MEMORANDUM

FILE NO: FH09-I-0025 through
FH09-I-0035

SUBJECT: Glacier Highway and
Trailhead (Amalga to Eagle
Beach) Site Visit

Photo 1: Upstream end of culvert 120

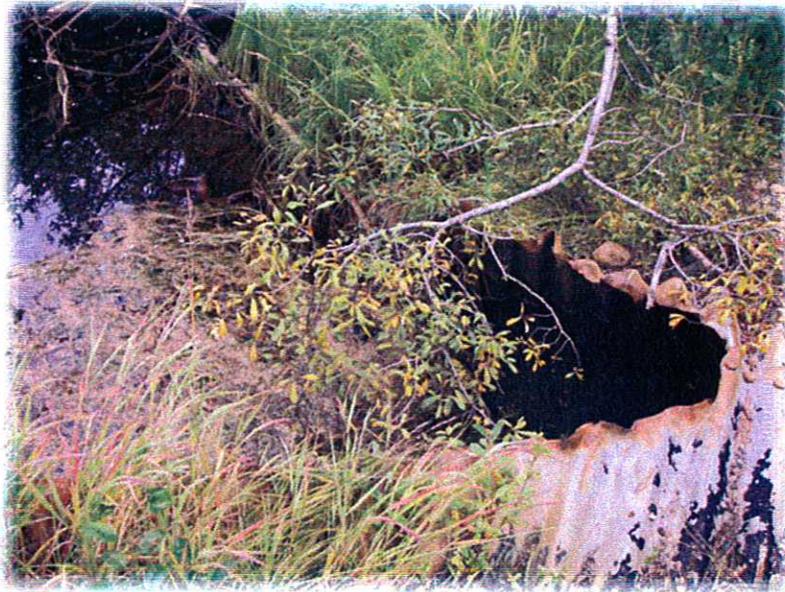
Pipes 115-121 (FH09-I-0025 through FH09-I-0029) have a significant amount of water in them, but no visible flow (Photo 1). Glenn proposes to dig a diversion ditch parallel to the stream and divert water into that ditch while the culvert is replaced, then divert the water back into the stream.
